Santa Monica Boulevard Transit Parkway Project
Santa Monica Blvd. Project Office
10350 Santa Monica Blvd., Suite 160
Los Angeles, CA 90025

July 14, 2005

The coalition of homeowner associations listed below represent the associations which border the Santa Monica Transitway Project. The coalition hereby presents its combined concerns over the Project.

Blow-up of north frontage road entrance. Measured distance is inconsistent with a 17' opening. Compare to the 4.67 meter opening of Club View.

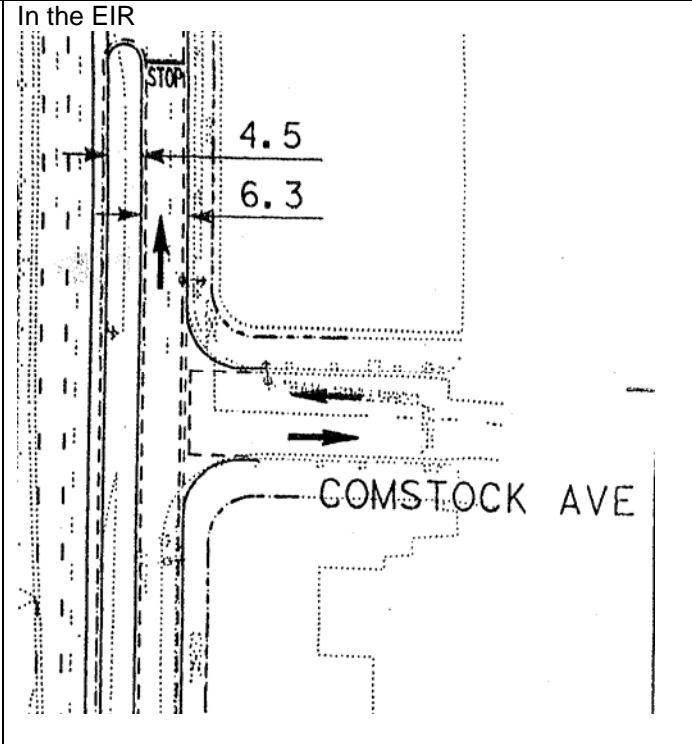
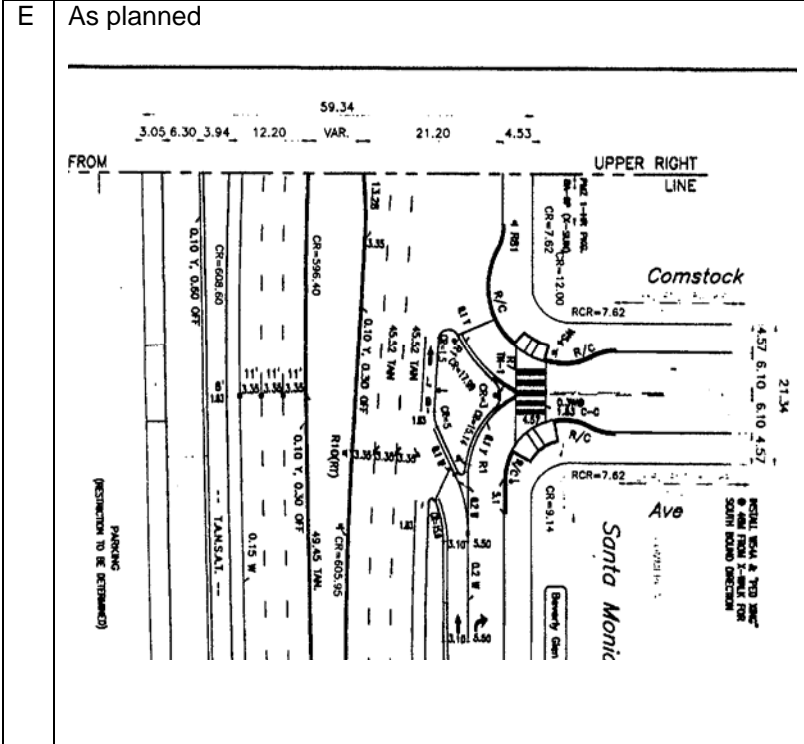
<p>North-Eastern Frontage Road Entry Width</p>	<p>CWW</p>	<p>E</p>	<p>The frontage road width can be measured at no more than 15' by measuring project plans.</p> <p>The project informed the group that the width was supposed to be 14.71 feet per project plans via Email sent by Carl Nelson on July 7, 2005.</p> <p>“...I do not know and we have deferred to finding out the answer from the LADOT. The discussion of a “state mandate” was actually a discussion of what we call the Work Area Traffic Control Handbook (WATCH Manual) and may not have any relevance in the design criteria used when designing the roughly 14.71-foot width at that point.</p> <p>The matter of the hard improvements actually being 17-feet is alarming and will be double checked by the Inspector tomorrow morning. If the improvements are found to differ from the plans – they will be considered Non-compliant and it will need to be corrected by the contractor”</p> <p>Several community members were present when an engineer measured plan specs at 14.71 feet.</p> <p>Actual built width is 17 feet – a 16% variation.</p> <p>The increased width violates a significant traffic mitigation element for the local neighborhood.</p>	<p>Adjust the width to promised dimensions.</p>

Comstock design change

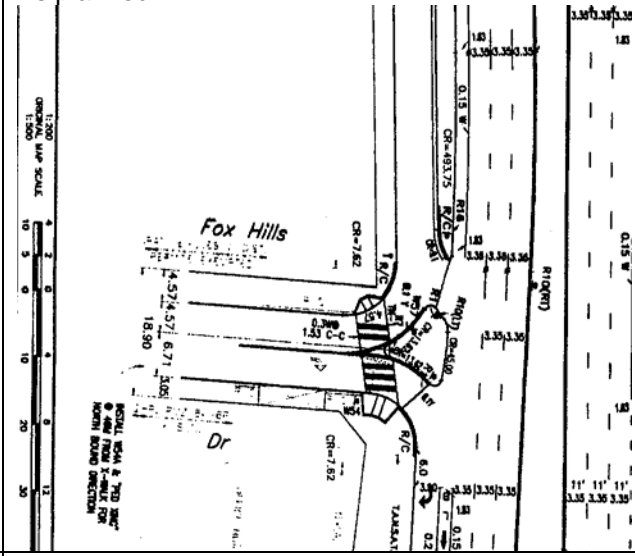
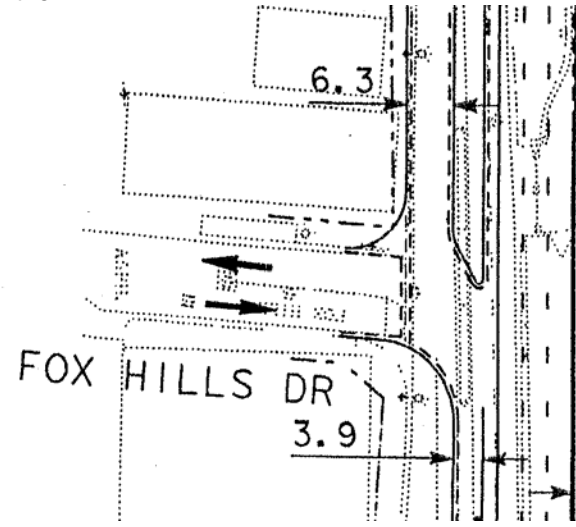
Through Lane – north frontage road Beverly Glen to Club View	CWW	E	The elimination of a through lane on the frontage road increases the likelihood that drivers will cut through the CWW area to get to Beverly Glen or to Wilshire. See Image E	Return to the plan for a through lane from Club View to Beverly Glen to encourage use of Beverly Glen for northbound travel. This includes any bump-outs or bulges at Comstock.

Fox Hills design change

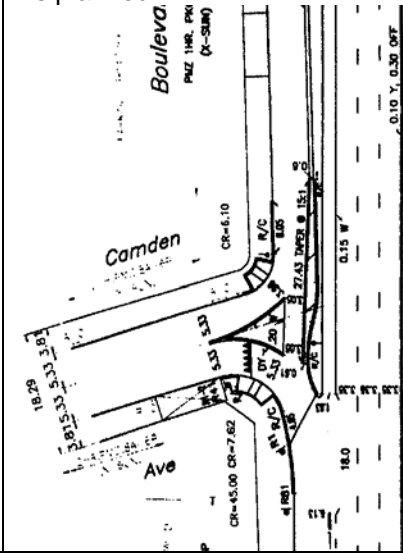
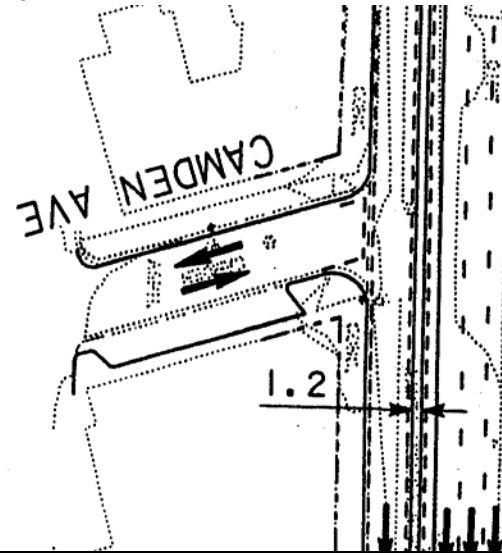
Issue	Group	Type	EIR Support/Discussion	Request/Solution
Fox Hills Island	7260	E	<p>The roadway configuration was changed to include an island which will encourage traffic to go into the tract.</p> <p>Image F shows the diagram for Fox Hills/SMB. Current plans represent a significant deviation from the EIR.</p> <p>The new configuration will direct traffic from the block between Benecia and Fox Hills into the Tract 7260 area.</p>	<p>Eliminate the island OR make Fox Hills one-way between the alley and Missouri with a physical barrier to prevent violation. Prevent the left turn from the alley onto Benecia SB. Re-pave the alley to make it a more attractive and more efficient path.</p>
Large Signs	All	E	<p>Section 6.11 aesthetics (and also Page 21 of the initial study) “Santa Monica Boulevard is designated as a scenic highway by the city of Los Angeles Department of city planning the corridor enjoys strong west to east vistas of Century City Mt. Baldy and other elements of a background skyline. The proposed project would not construct structures (overpasses, bridges, etc.) that would disrupt existing vistas. “</p> <p>The EIR, despite numerous opportunities, did not provide any mention of large freeway signs.</p> <p>Section 1. “Classic Boulevard. ...”This alternative evokes the great boulevards of Europe, and provides neighborhood protection from the main roadway. It would be similar to parts of San Vicente... in Los Angeles.”</p> <p>See Images A-C. The large signs are inconsistent with western San Vicente which is provided as an example in the EIR. Both San Vicente in Brentwood and San Vicente east of Beverly Hills are shown. San Vicente to the east of Beverly Hills only has large unattractive signage at La Cienega.</p> <p>Page 3 -- 28 “the key objective of the transit parkway concept is to improve the visual quality of the route. The classic Boulevard alternative would embody a variety of components that are intended to create the parkway image.”</p> <p>Large signs are not consistent with a parkway image.</p>	<p>Reduce the size of the large signs to the minimum required by law.</p> <p>Convert large overhead signs for Overland Avenue to road-side signs consistent with others along the project.</p>

Camden design change

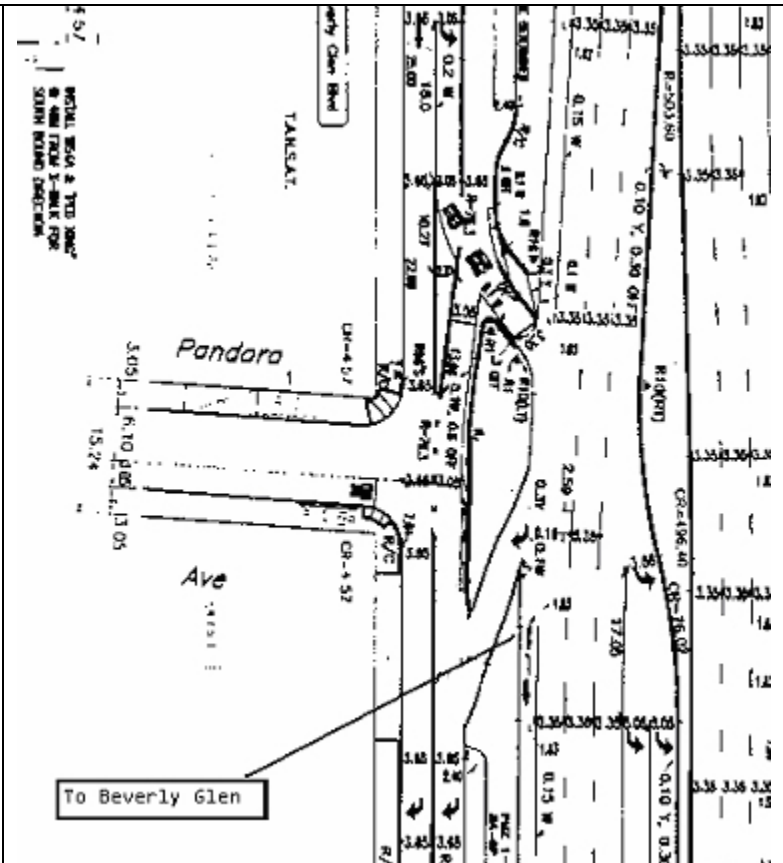
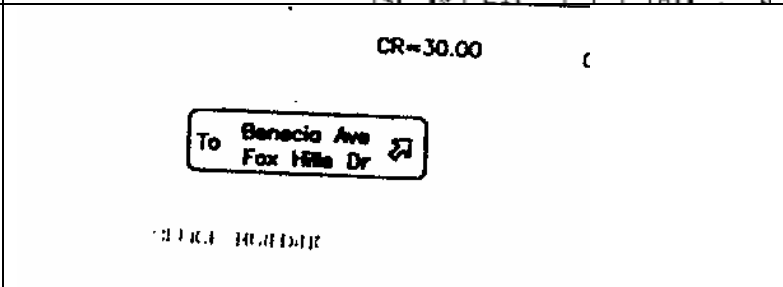
<p>As proposed by the HOAs. A merge lane from BSMB to LSMB allows drivers to get to SB-BG from BSMB. Access to WB-LSMB is eliminated in favor of dual right turn lanes onto SB-BG.</p>
J		<p>The resident's concern is that signs pointing to local streets, especially where the project design is faulty, will provide motorists with an invitation to seek alternate routes through our neighborhoods.</p>	<p>Example of local street sign to be removed by request of the relevant HOA.</p>
K	<p>As planned</p>	<p>In the EIR</p>	<p>Additional lane design change. Left has 2 WB lanes on LSMB, right is the desired FEIR design with one single WB lane.</p>

EIR map showing a 4-way stop at LSMB and Pandora

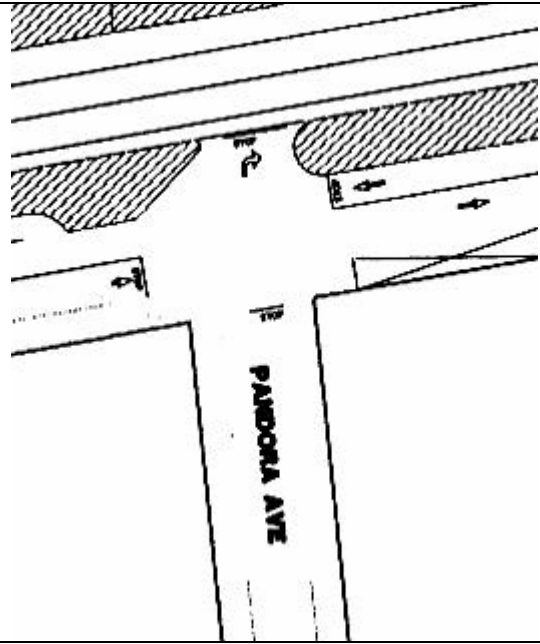
EB/WB stop signs at Pandora on LSMB	WSSM	E	Draft EIR FIGURE 3.3-9 shows 4-way stop at LSMB and Pandora. See Image L below.	Add stop signs on EB and WB LSMB at Pandora

Suggested modification to the north frontage road between Beverly Glen and Club View – specifically adding an egress only lan, allowing for through traffic at Comstock and eliminating the Comstock island.

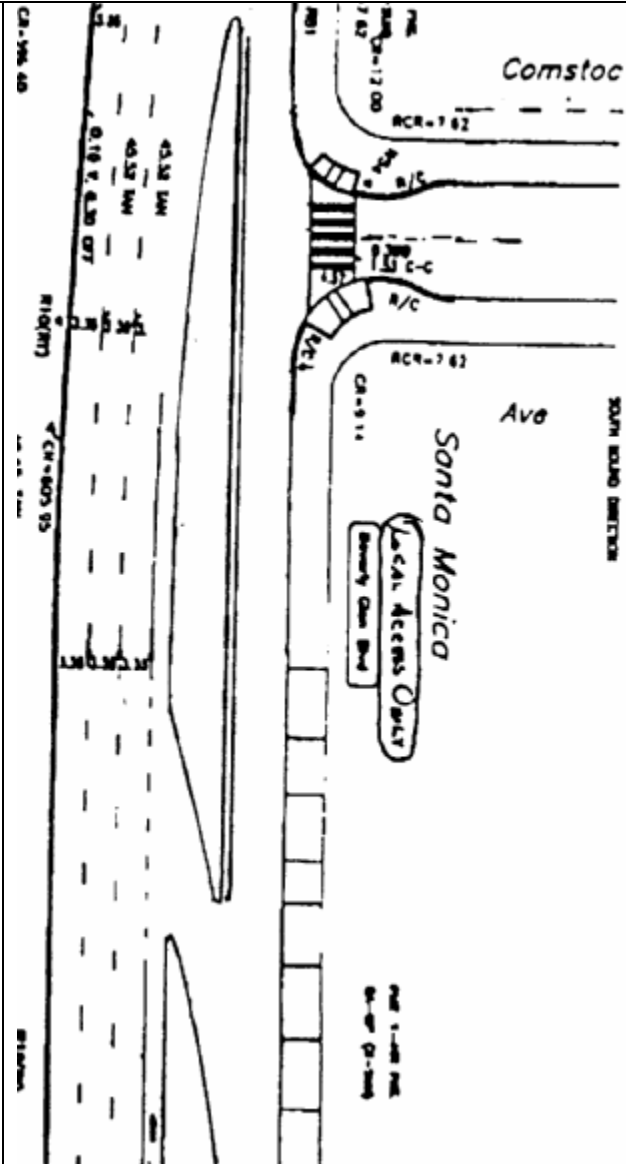
Egress-Only lane from north frontage road to WB-BSMB between Warnall/Comstock.	CWW	E	Drivers will not have an opportunity to exit the frontage road until it is too late or dangerous to cross BSMB to head SB on BG, or head EB on BSMB. An opening was included in the draft EIR for this purpose. At that time the median between BSMB and the frontage road was a very narrow curb which also allowed easy ingress to Comstock. To reduce ingress for cut through traffic, CWW requested and the MTA agreed to eliminate this opening. In the current design, all medians are very wide and many ingress only and egress only lanes have been added to improve safety over the original EIR design. Equal safety treatment should be accorded the CWW residents and motorists using the businesses on that frontage road.	Add a merge lane on the north frontage road between Warnall and Comstock. See Image M.
Local street signs	All	M	Per agreement with LADOT (Glenn Ogura) each group will make a request on HOA stationery to have local street signs removed from the boulevard and to have DOT respond to complaints by referring complainants to the HOAs. The format for the letter was to have been provided by Mr. Ogura. We are still awaiting the format definition. An example would be the Fox Hills/Benecia sign as shown in Image J.

Shows the promised U-turn at Century Park West – from the DEIR.

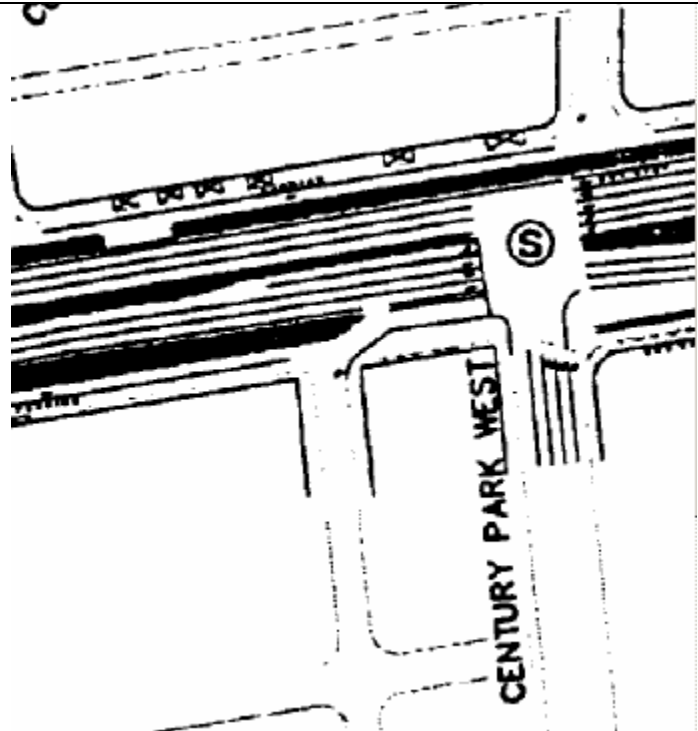
No EB-BSMB to SB-BG turn movement	7260, WSSM	H	<p>The lack of any way for drivers to go south from BSMB will cause cut-through via Benecia to BG. Without this modification, any drivers wanting to go south on BG will be forced to cut through Tract 7260. Under the current plan, drivers would have to remember to transfer to LSMB at Overland if they wanted to make the right turn. This does not include those drivers who join EB-SMB east of Overland from the north. See the community's proposed plan to resolve this problem as Image I below.</p>	Allow the turn movement as described.
CPW U-Turn	7260	E	<p>The failure to provide a U-turn at CPW means that drivers will have to back-track to Avenue of the Stars to go west on SMB. This makes the likelihood of cut-through traffic far greater.</p> <p>The EIR states that a U-turn at CPW will occur as follows:</p> <p>Page 4.1 -- 48 "It would not be easy to merge across three eastbound lanes on Santa Monica Blvd., turn left onto northbound Beverly Glen Boulevard, so these movements would likely shift to one of three alternate routes. They could be made by exiting the frontage road west of Beverly Glen Boulevard and traveling east on Santa Monica Boulevard to Century Park West and making a U-turn..."</p> <p>Written responses page 2 -- 13 Response T2.... "Traffic attempting to exit the frontage road near Pandora Avenue and travel north on Beverly then will have difficulty merging over to the left turn lanes of Beverly Glen. To accommodate that maneuver a U-turn has been provided at Century Park West. "</p> <p>Image N shows an early design that depicts the U-turn.</p>	Return the U-Turn movement to CPW.
